ITEM 4. DEVELOPMENT APPLICATION: 50 BRIDGE STREET SYDNEY**FILE NO: D/2015/929****DEVELOPMENT APPLICATION NO: D/2015/929****SUMMARY**

Proposal Summary: Stage 2 Integrated Development application for the redevelopment of the existing AMP Centre tower at 50 Bridge Street, Sydney. The site is part of the Quay Quarter Sydney (QQS) precinct.

Figure 33: Non-compliance with Stage 1 envelope – Block 5

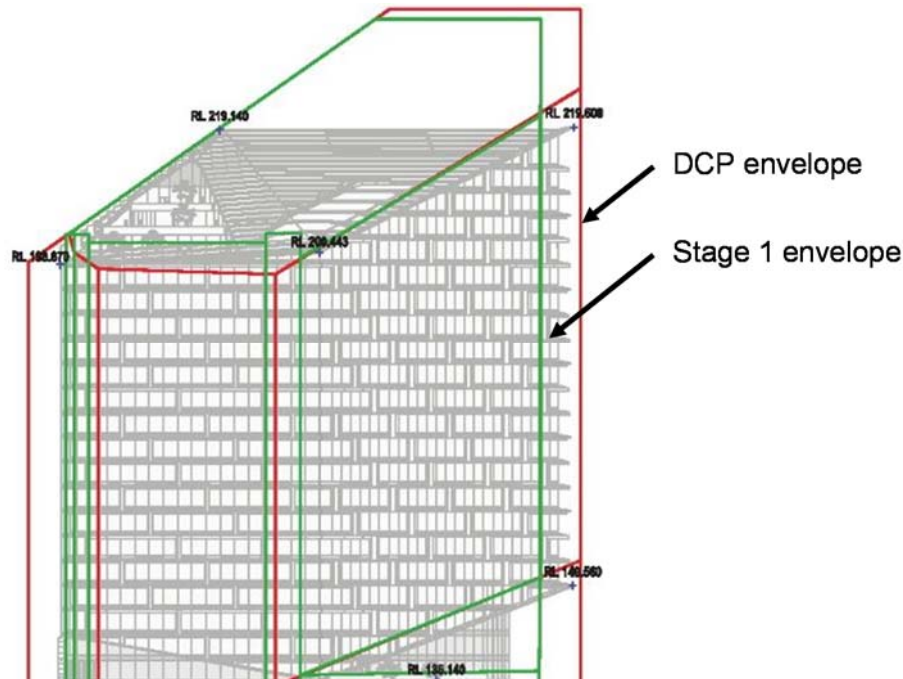
69. The proposal presents a non-compliance with the Stage 1 envelope on Levels 35 to 49 (Block 5). This non-compliance is a result of the 'stacked block' twisted form of the proposal, which causes the building to sit outside of the approved Stage 1 DA envelope (Figure 33). Block 5 extends beyond the Stage 1 envelope northward by approximately 4.1m to 4.7m

Figure 34: Non-compliance with DCP envelope – southwest corner and sun shading devices

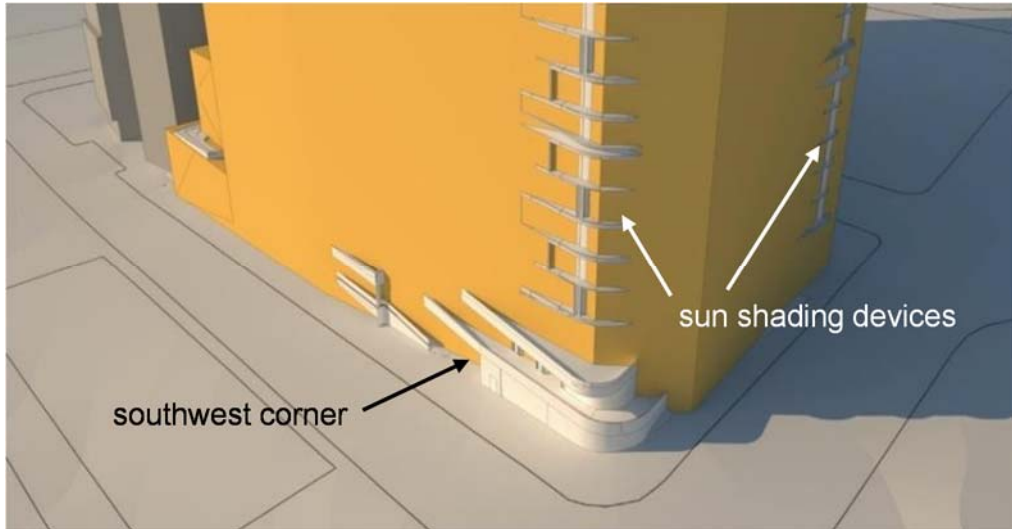
73. The sun-shading frames of the facade extend beyond the DCP envelope by approximately 300-400mm around the southern edges of the tower massing (see Figure 34). These projections do not consist of occupiable space.

75. The podium massing extends beyond the DCP envelope along the northeast, northwest and southwest corners by a margin of approximately 500-1500mm.
76. The southwest corner along Bridge Street exceeds the current height of the existing fresh air-intake, but it does not extend as far towards Bridge Street (Figure 34).

Figure 35: Non-compliance with DCP envelope – northwest corner

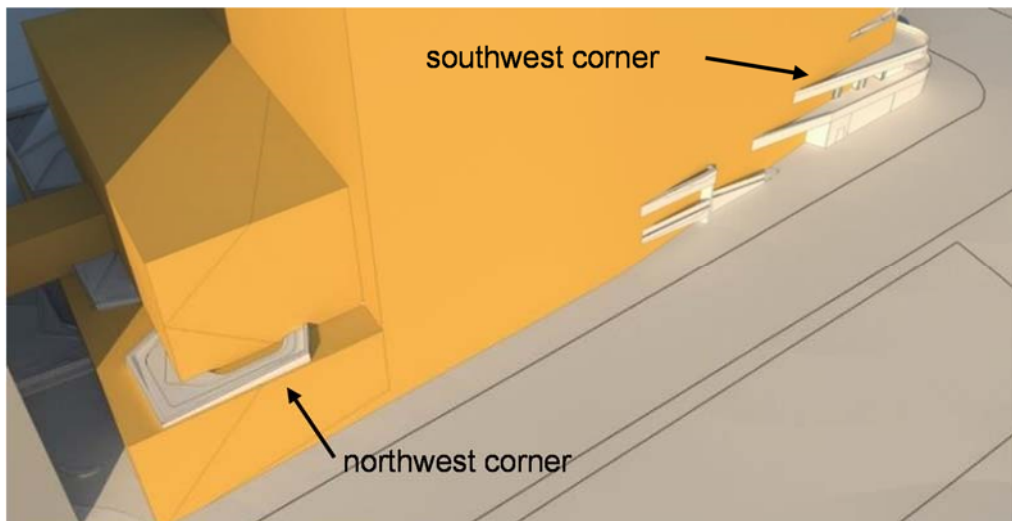
77. The northwest corner encroachment is contributed to allowing a suitable parapet/guardrail to the publically accessible podium roof top terrace (Figure 35).

Figure 36: Non-compliance with DCP envelope – northeast corner and sun shading devices

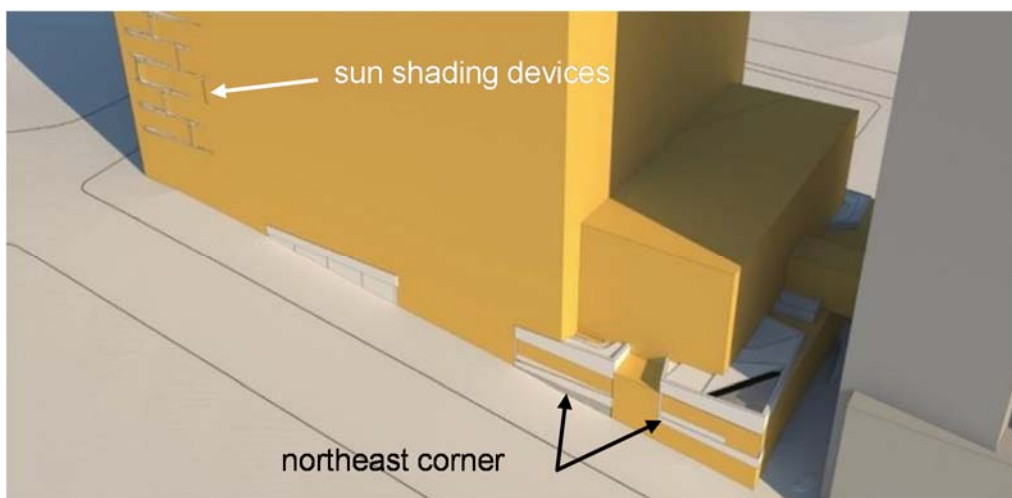
78. The northeast corner encroachment (Figure 36) is a response to direction provided by the City and the Design Advisory Panel to further activate Phillip Street. As such, podium massing has been pulled to the site boundary and corner. The result assists in activating the edge of Phillip Street and Goldsborough Lane while also increasing the distance between the market hall kitchen exhaust from the podium roof top terrace.

Figure 40: Podium opportunities – active edges

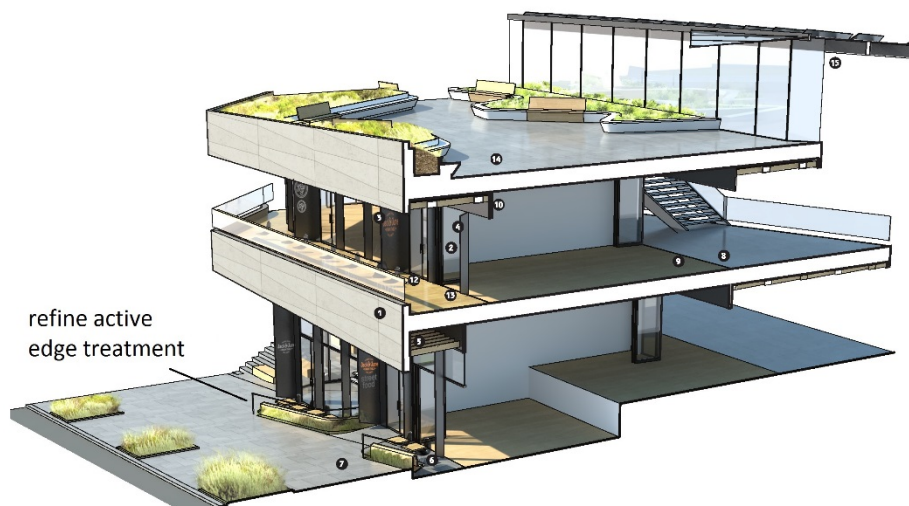
103. The podium design has been reviewed by Council's City Design Unit and Heritage and Urban Design Specialists, who have identified a number of opportunities for the podium to be further refined and detailed. As such, appropriate conditions have been recommended to address the below opportunities:

- (a) the continual line of shopfront glazing of the podium should be broken up by some wall elements of sandstone with fine details, to create greater solidity and verticality;
- (b) space for spill-out along Young Street should be maximised within the constraints of maintaining good pedestrian circulation space. The proposed high back benches and landscape enclosures along Young Street have the potential to detract from valuable pedestrian movement space (Figure 40); and
- (c) investigations should be made to improve the appearance of the Young Street escalators by either setting back further from the footway or relocating to the southern side of the entry (Figure 41).

Figure 44: Amended Goldsbrough Lane through site link proposal

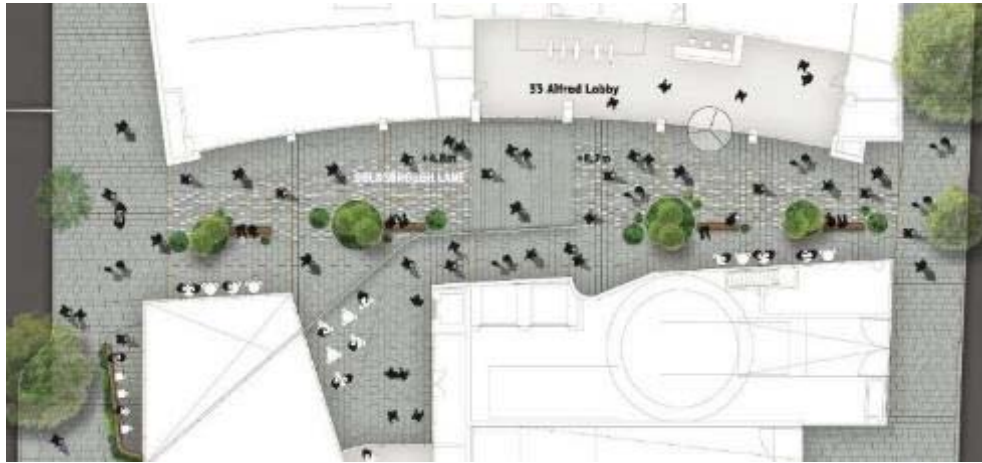
114. The proposal has been amended to largely address these concerns (Figures 26 and 44). The amended design shows a compliant through site link that meets the objectives of the DCP and Stage 1 approval, subject to minor amendments. Benefits of the amended design are as follows:
- (a) the space has been designed as a permeable pedestrian thoroughfare;
 - (b) the redesign allows for clear views to the Justice and Police Museum to the east and Customs House and Hinchcliff House to the west;

- (c) the deletion of retail spaces within the through site link allows the space to read as a laneway as intended by the reinstatement of Goldsbrough Lane;
- (d) the relocation of the 33 Alfred Street entry allows for the intact gold glass spandrel panels of this building to remain intact and undisturbed.

115. Conditions have been recommended to require minor amendments to the design of the laneway as follows:
- (a) provision of a longer staircase with a deeper landing and wider steps to contribute to the civic nature of the space and achieve a comfortable transition between the two levels; and
 - (b) removal of the proposed structural column in front of Lift 28 to allow for increased pedestrian circulation.

Figure 47: Proposed Phillip Street driveway

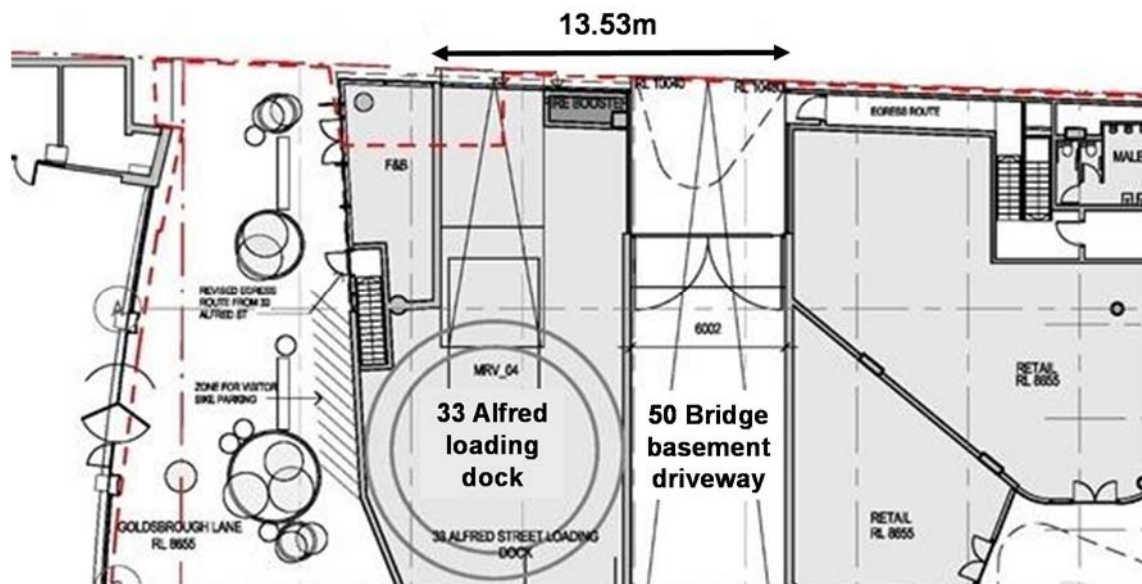
134. A new loading dock is provided for the 33 Alfred Street building containing 1 truck holding bay and a turntable, accessed via Phillip Street (Figure 47).

135. The provision of the new Phillip Street car park entry driveway and new loading dock driveway for 33 Alfred Street will result in a vehicular crossover 13.53m in width. This results in a poor outcome for pedestrian safety and amenity (Figure 25 and 47). The crossing is also wider than the crossover width approved under the Stage 1 consent, which specified a crossing of 13m.

136. The applicant was requested to investigate combining the car park and loading entry by locating the loading dock within the basement. The applicant was also requested to investigate opportunities to reduce the overall width of the combined crossing to improve pedestrian safety and amenity.

Figure 48: Bridge and Phillip Street corner public domain

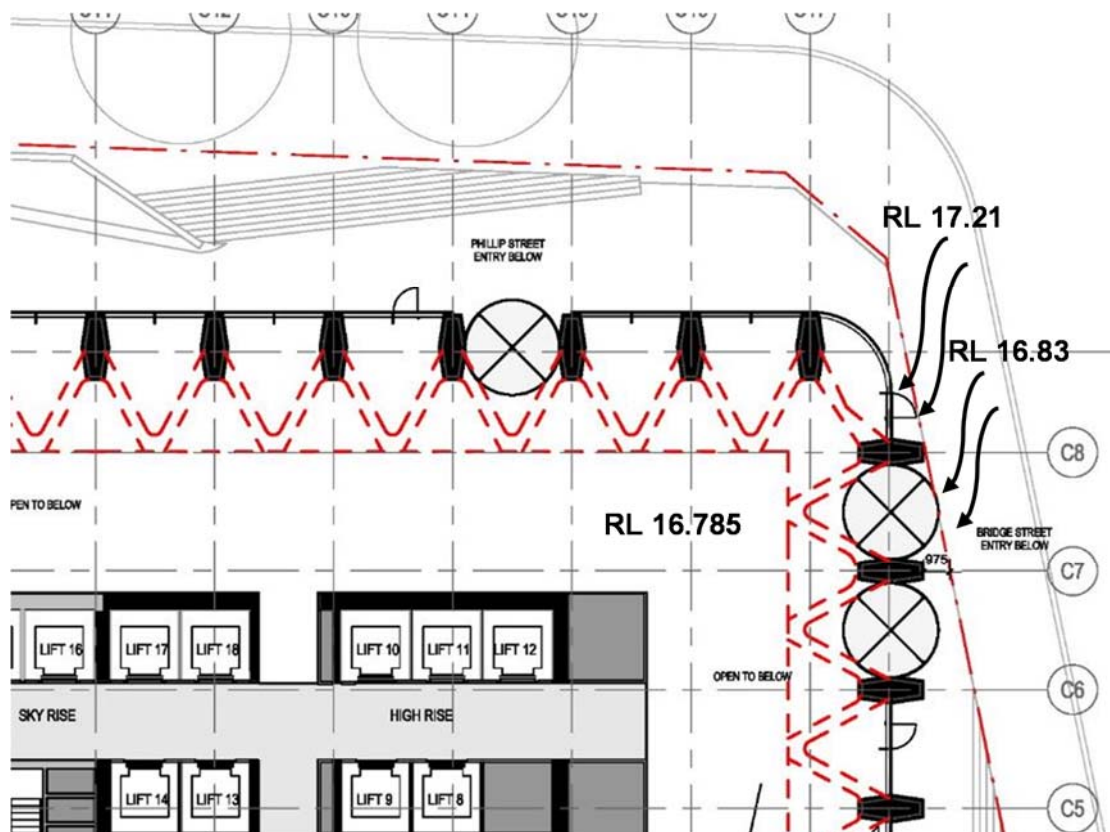
142. The current design shows that the ground level of the tower lobby is lower than the kerb levels at the corner of Phillip and Bridge Streets. The public domain at these frontages will be required to grade towards the kerbs to prevent localised runoff flowing into the building (see Figure 48). A retaining wall may be required to accommodate the level difference.

143. In order to prevent localised runoff flowing into the building entries at the corner of Phillip and Bridge Streets, these entries will need to be revised to address this issue. Appropriate conditions have been recommended.

Figure 49: First Government House Place solar access

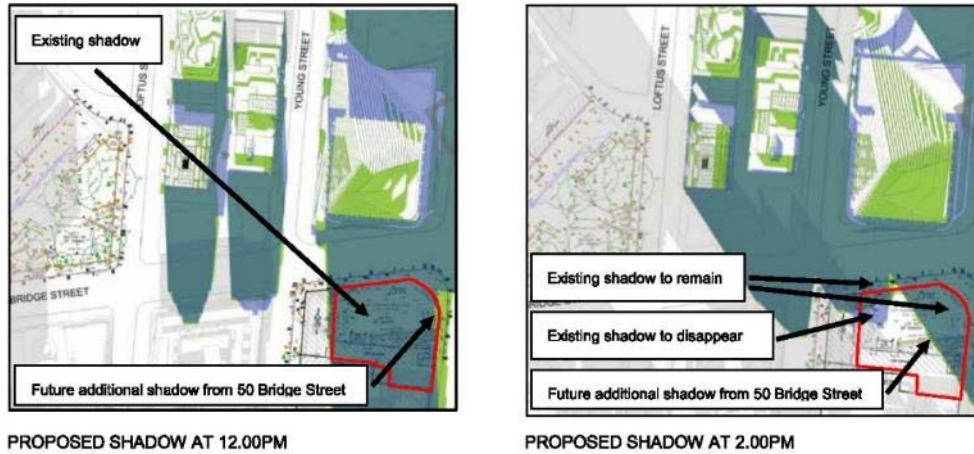
149. The submitted shadow diagrams show that the proposal will cast a minimal amount of additional shadow on First Government House Place between 12:00pm and 2.00pm on 21 June. However, this loss will be offset by a reduced amount of existing shadow (at 2:00pm) as a result of a reduction in the scale of the existing building at 15-17 Young Street (Building C within the Young and Loftus block). In net terms, the proposal will not cause additional overshadowing, as shown in Figure 49 and outlined below:

- (a) the area of sunlight that will be overshadowed by the proposal at 12:00pm is 14m²;
 - (b) at 2.00pm, there is a 40m² reduction in overshadowing compared to the existing condition; and

- (c) the 2.00pm shadow reduction and the 12:00pm extra overshadowing results in a net benefit of 26m² of extra sunlight (40m² – 14m² = 26m²).

150. In light of the above, the proposal is considered satisfactory with regard to solar access to First Government House Place.

Figure 50: Proposed demolition and retention of existing structure

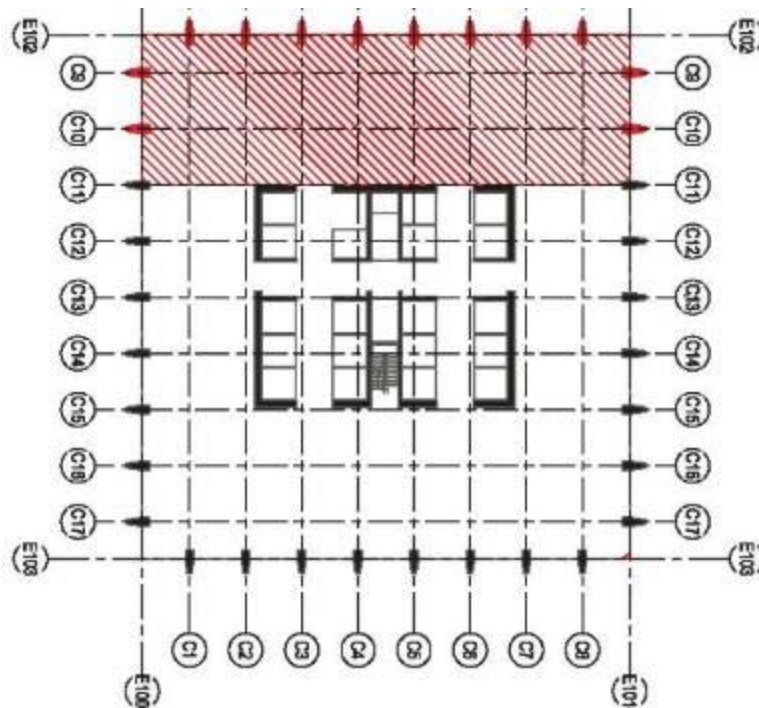
152. The proposal addresses this requirement by retaining a substantial portion of the existing building. Approximately 30% of the existing building, including slabs and exterior columns is proposed to be demolished north of the existing core (Figure 50). The remaining structure, core and slabs will be retained for the new design. As a result of the redesign, the facades will be removed and most of the basement and podium will be demolished.

153. A structural report has been submitted that supports the partial demolition and retention of existing structure. The proposal is acceptable in this regard.
